Assessment Ride along Hornby Street Separated Bike Lane
HUB Vancouver/UBC Committee
2013/10/05

Executive Summary

Dunsmuir separated bike lane
where it intersects with Hornby

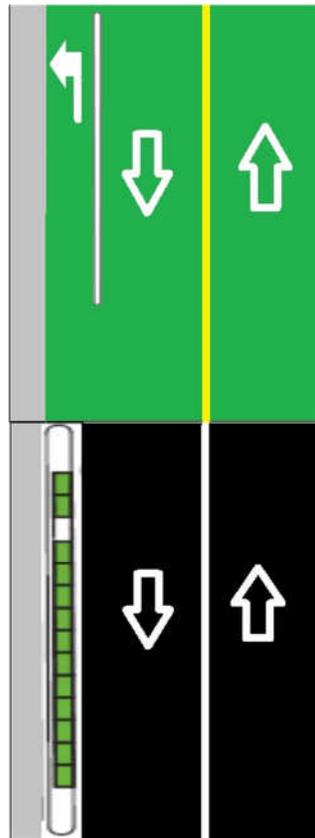
The intersection of Hornsby and Dunsmuir is complex and non-intuitive for those riding bikes and those new to riding them. It is not obvious how and when one should make a turn, especially from the Dunsmuir separated bike lane westbound onto Hornby southbound.

The use or function of the bike box/hazard area on Dunsmuir is puzzling. It is unclear where to position yourself in preparation for making a left turn from Dunsmuir onto Hornby southbound. There is a collision hazard with straight through and turning traffic crossing paths. Also, when the lights change, there are often pedestrians crossing in front of cyclists. This is true for those approaching from Dunsmuir eastbound and also for those approaching from Hornby southbound and wishing to

proceed on Dunsmuir eastbound. Add pedestrians crossing in the crosswalk and this becomes even more challenging.

A possible solution, shown above, is to extend the barrier on Dunsmuir by placing a low, flat concrete curb (island) along the south side of the green bike box/hazard area. A narrow left turn lane could be placed beside the curb with arrows indicating that this is a left turn lane. This narrow island would indicate some separation, give some protection, as well as providing a foot rest for cyclists turning left. Bike lanes should be clearly marked with lane separation and directional markings.

HUB Vancouver/UBC recommends that the east crosswalk be moved further east, so that the space for cyclists waiting to turn is that bit closer to the intersection. (The turn area for cyclists would be located where the current crosswalk is.)

Dunsmuir westbound at Hornby: Bike lanes with left-turn lane, low curb, clearly marked lane separation and directional markings

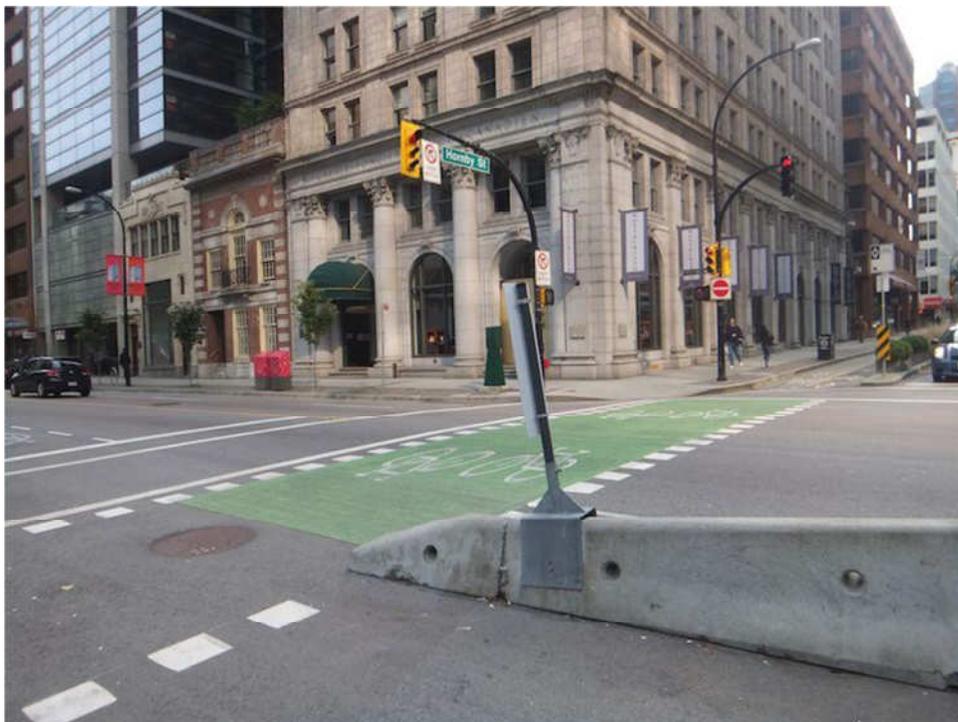
This document mentioned earlier that, following the practice in the Burrard/Cornwall intersection, short dashed lines could be added to other intersections, to aid navigation through the intersection. It would be beneficial if similar markings were provided for those cycling through complex intersections like Hornby-Dunsmuir. For example, the left-turn line from Dunsmuir westbound to Hornby southbound and the left-

turn line from Hornby southbound to Dunsmuir eastbound could be marked to show the preferred routing for those making left turns.

Suggested directional markings at Hornby and Hastings with green paint and short dashed lines

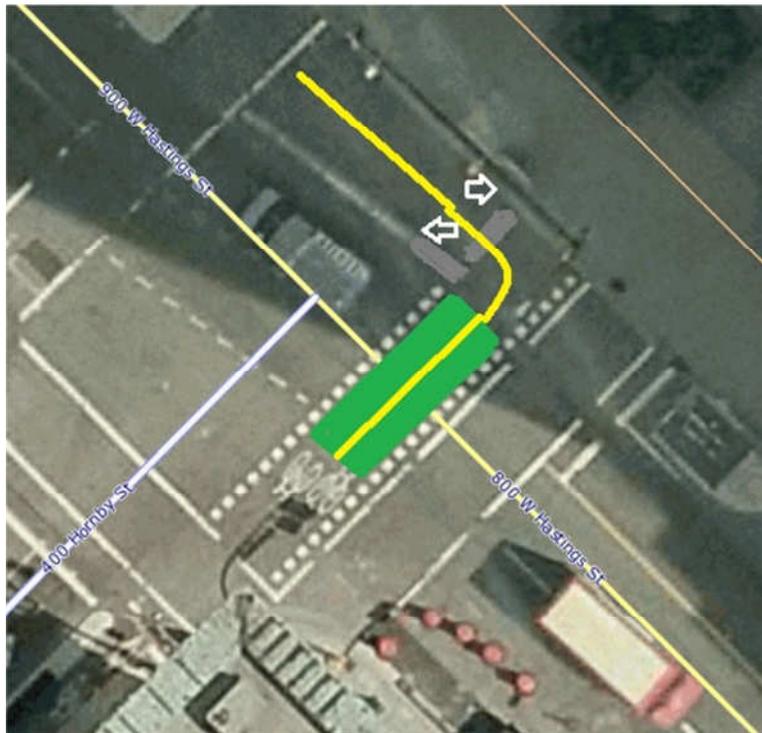
The east end of the concrete divider (see photo above) is in the way of turning south onto Hornby from Cordova. It does not provide a place where a cyclist can rest their foot before turning. HUB Vancouver suggests that the barricade be shortened on the east end in order to more easily make the turn. Also, the diamond markings do not provide much information. It would be better to use directional markings as exist on the Seawall Greenway (see photo below).

The final result might look like this:
